BENSEN B8 MODIFICATION
WITH DOGLEG KEEL, TALL
TAIL, AND SUZUKI ENGINE.

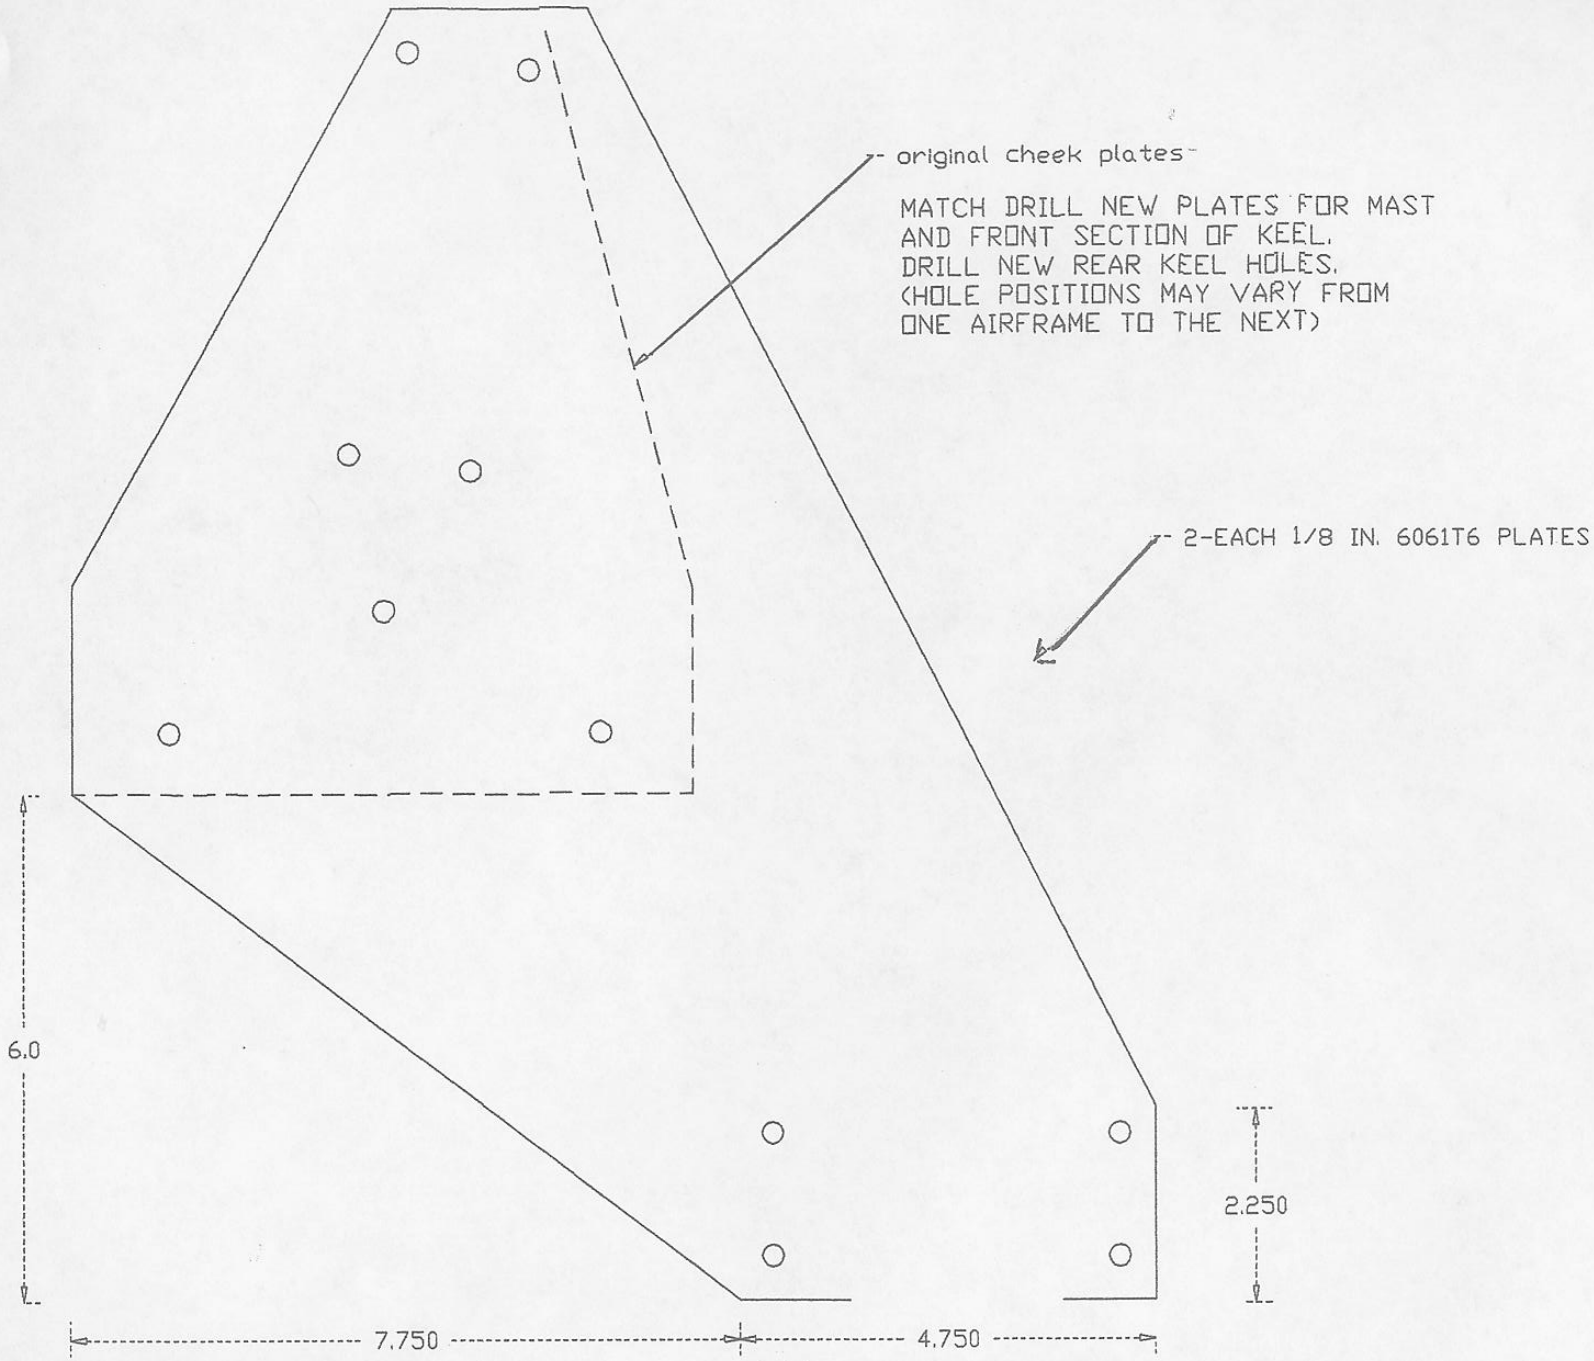
original cheek plates
MATCH DRILL NEW PLATES FOR MAST
AND FRONT SECTION OF KEEL.
DRILL NEW REAR KEEL HOLES.
(HOLE POSITIONS MAY VARY FROM
ONE AIRFRAME TO THE NEXT)
2-EACH 1/8 IN. 6061T6 PLATES
6.0
2.250
7.750
4.750

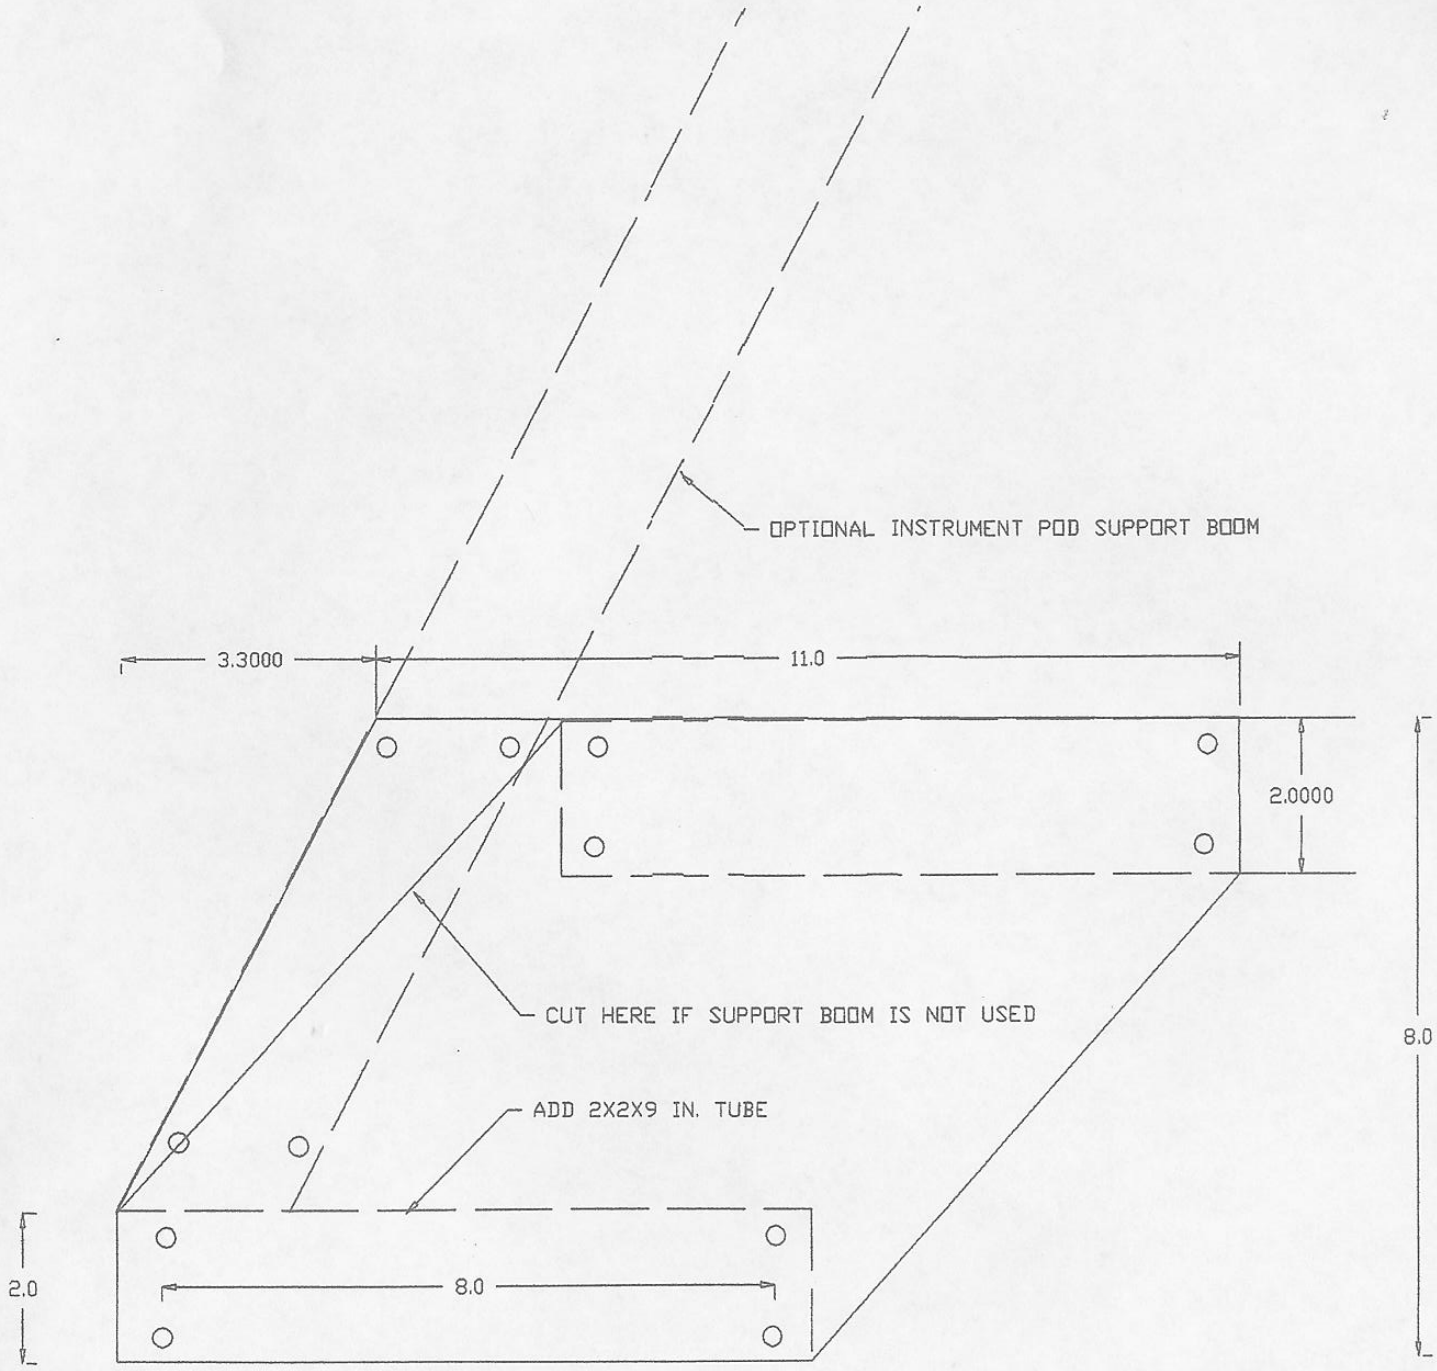
OPTIONAL INSTRUMENT POD SUPPORT BOOM
3.3000
11.0
2.0000
8.0
CUT HERE IF SUPPORT BOOM IS NOT USED
ADD 2X2X9 IN. TUBE
2.0
8.0
